***Ducted Systems
Technical Services
Service Letter***

Letter: **YSR-003-25**

Subject: HH8 horizontal discharge heat pump field wiring.

Product: HH824E2S11, HH836E2S11, HH860E2S11

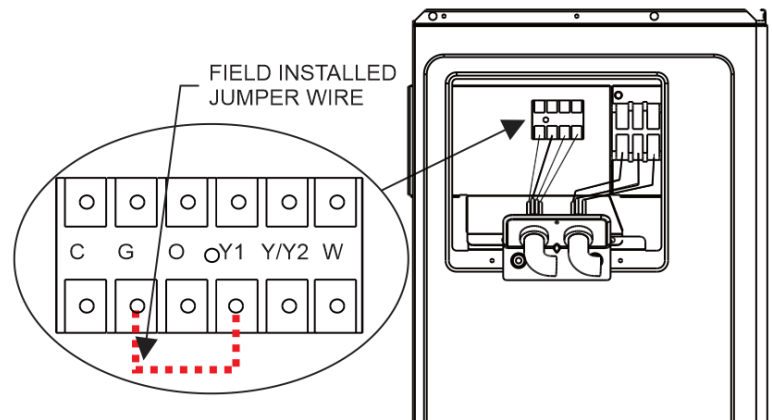
An error in the low voltage field wiring diagrams was recently discovered. 24v power that supplies the outdoor section Y/Y2 and W terminals (unit outputs) originates from the outdoor section G terminal which is currently shown as not in use. For the system to function properly, a field installed jumper **MUST** be installed at the outdoor section field wiring barrier strip between **Y1** and **G** as shown to the right.
